## National Committee on Uniform Traffic Control Devices

### Proposed Language as approved by the NCUTCD on June 23, 2011, for new section on Pedestrian Channelizing Devices

#### Section 6F.xx Pedestrian Channelizing Devices [suggest placing after Section 6F.63 Channelizing Devices]

# Figure 6F-XX Pedestrian Channelizing Device

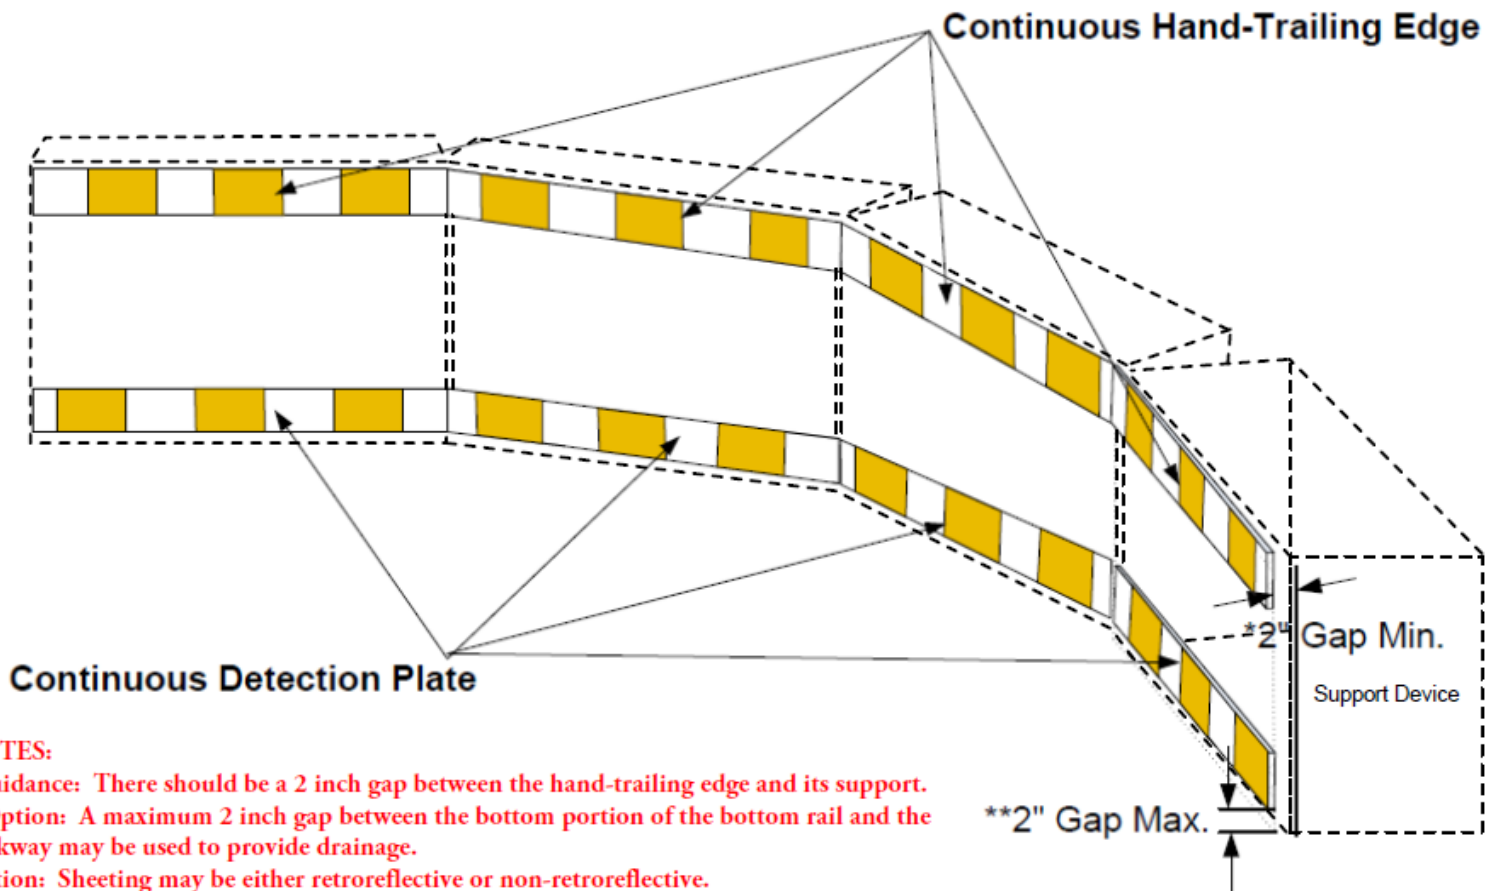
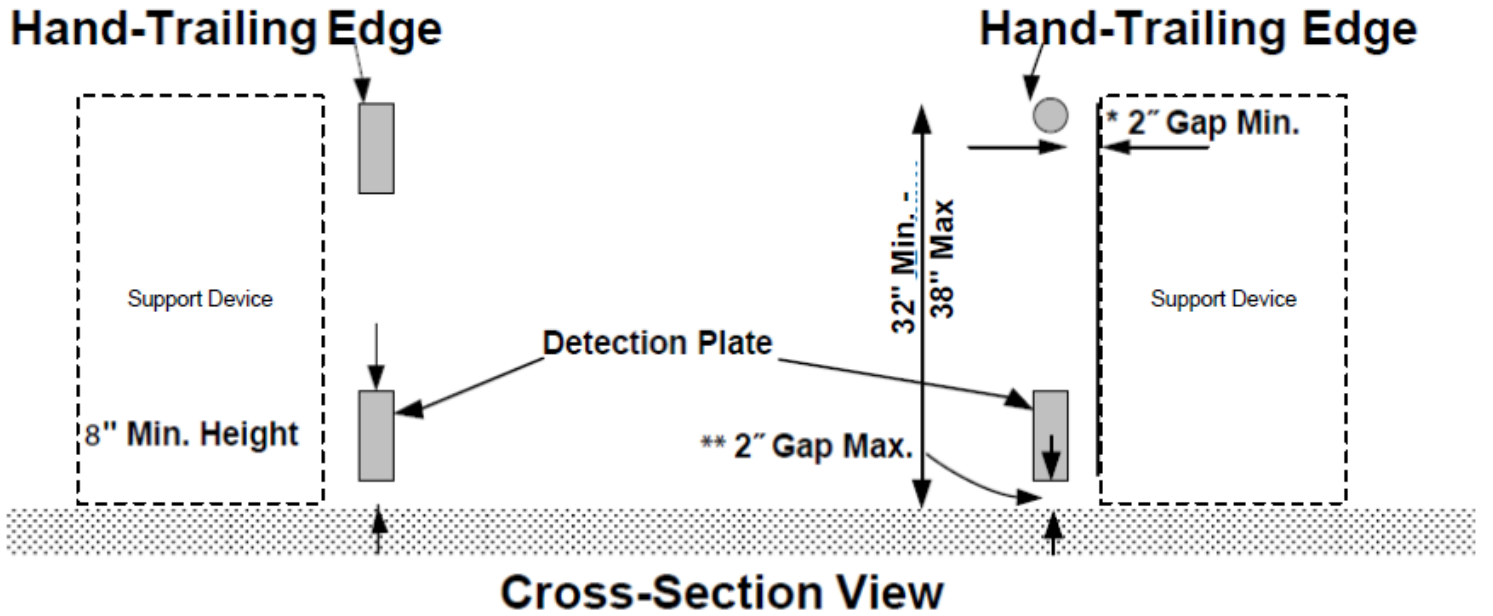
12 | A Hand-Trailing Edge is the upper surface of the upper rail on a pedestrian channelizing device,  
13 | as shown in Figure xx. It is provided to allow pedestrians with limited vision to follow the pedestrian  
14 | channelizing device with their hand. The Hand-Trailing Edge is not a weight bearing railing.

- \*Guidance: There should be a 2 inch gap between the hand-trailing edge and its support.
- \*\*Option: A maximum 2 inch gap between the bottom portion of the bottom rail and the walkway may be used to provide drainage.
- Option: Sheeting may be either retroreflective or non-retroreflective.
- Option: Sheeting panels may be either vertical or at a 45 degree angle.
- Option: Hand-Trailing Edges and/or Detection Plates are optional for continuous walls.
